ITEM FOR ENVIRONMENTAL COMMISSION AGENDA

NAME & NUMBER OF PROJECT: COA Fire & EMS Station - Davenport Village
SP-2021-0121D

REQUEST: Variance request is as follows:
Vary 25-8-302(A)(2) to allow construction of a parking area on a slope with a gradient of more than 15 percent.

REQUEST: Variance request is as follows:
Vary 25-8-341 to allow cut over four feet to 17 feet.

EXHIBIT 3
SLOPE MAP

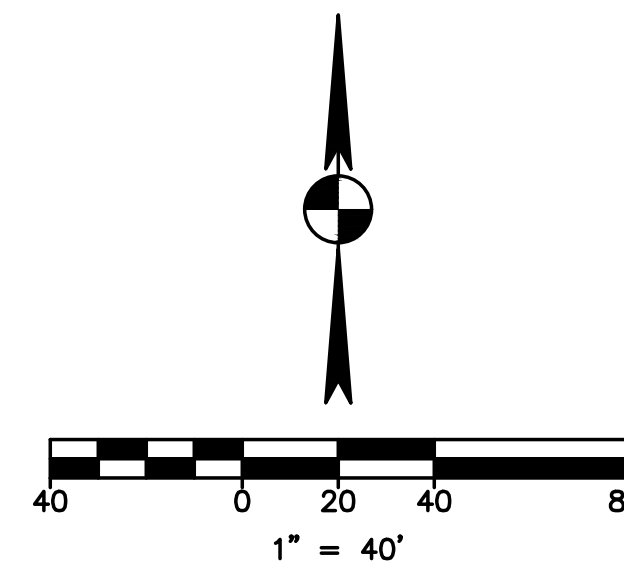
Yes This variance is for building a surface parking lot to be constructed on an area with slopes greater than 15 percent.

The parking lot is minimally sized to accommodate the number of employees that will be at this station.

Alternative layouts were considered. However, design is constrained by the maximum allowable slope of 15 percent for the emergency vehicles to access Westlake Dr.

STAFF RECOMMENDATION: Staff recommends this variance, having determined the findings of fact to have been met.

STAFF CONDITION: Applicant will provide landscape plan, including mitigation for removed trees, to provide enhanced soil stabilization and water quality for the site.

CUT/FILL GRADING EXHIBIT

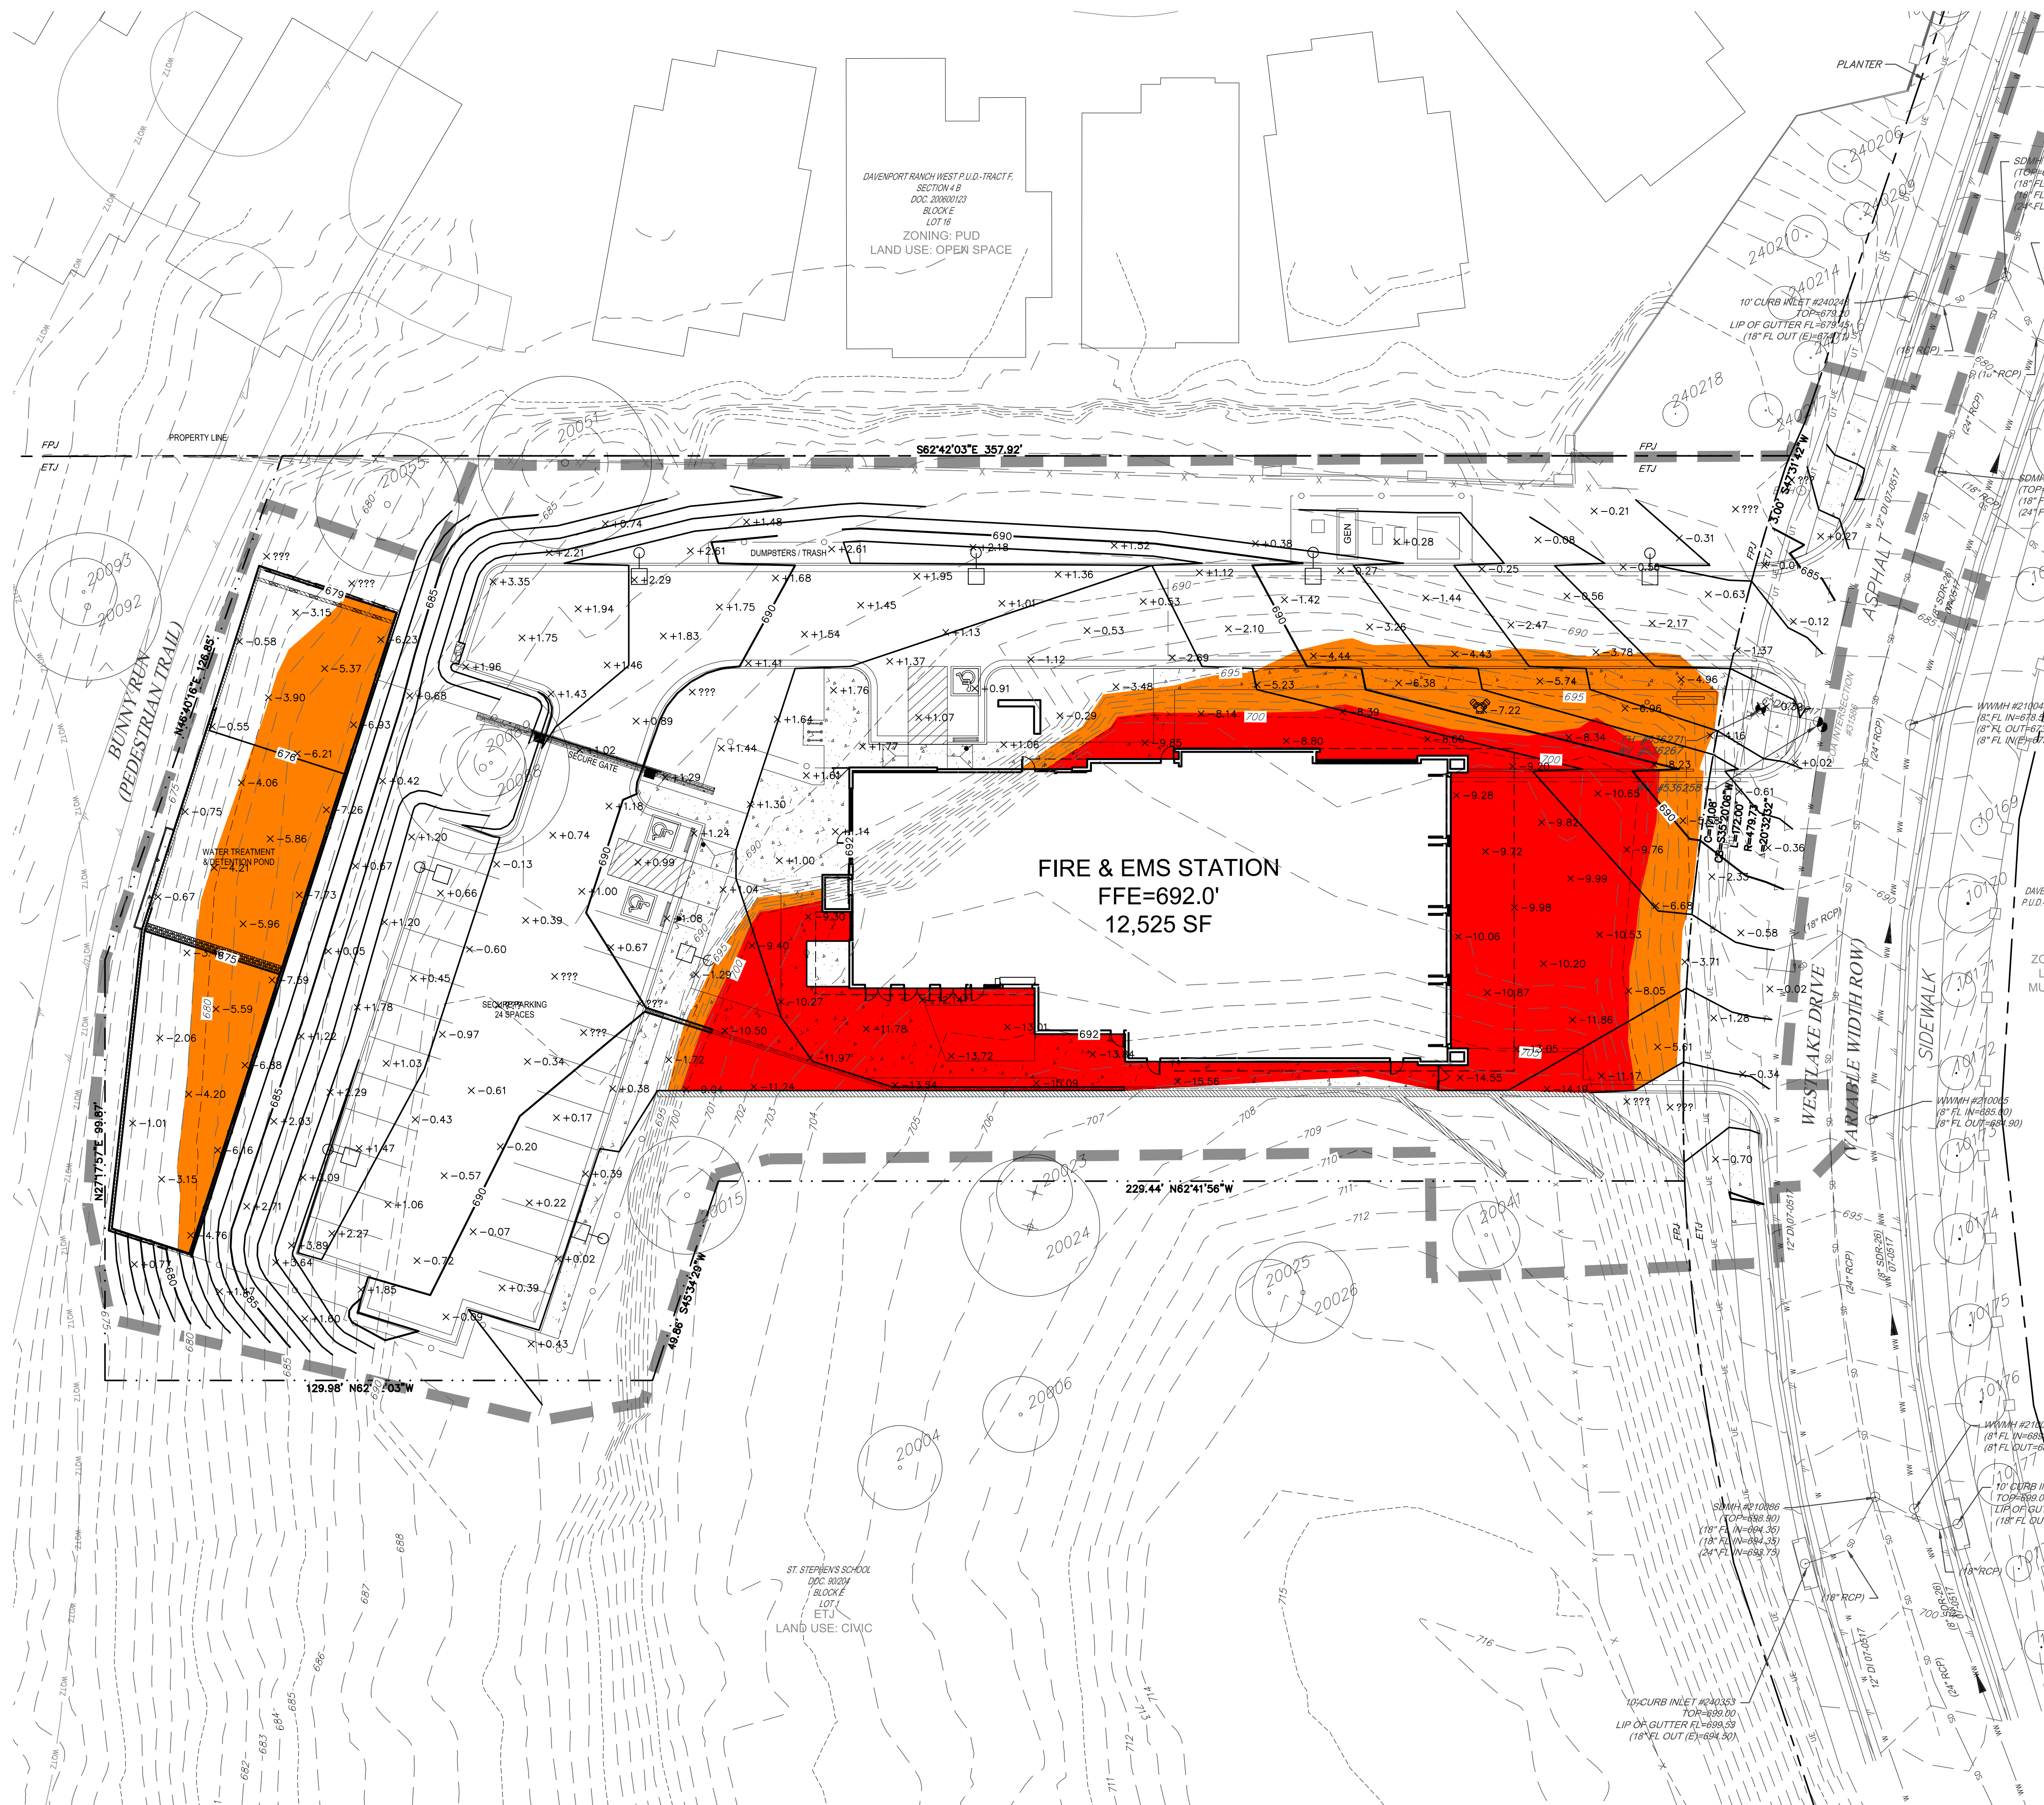
Yes This variance is to cut over 4 feet for the pond and for placement of the building and drive.

Alternative layouts were considered. However, design is constrained by the maximum allowable slope of 15 percent for the emergency vehicles to access Westlake Dr.

Yes The cut will be stabilized with a retaining wall. Erosion and sedimentation controls will be code compliant and appropriate for construction on slopes.

STAFF RECOMMENDATION: Staff recommends this variance, having determined the findings of fact to have been met.

STAFF CONDITION: Applicant will provide landscape plan, including mitigation for removed trees, to provide enhanced soil stabilization and water quality for the site.
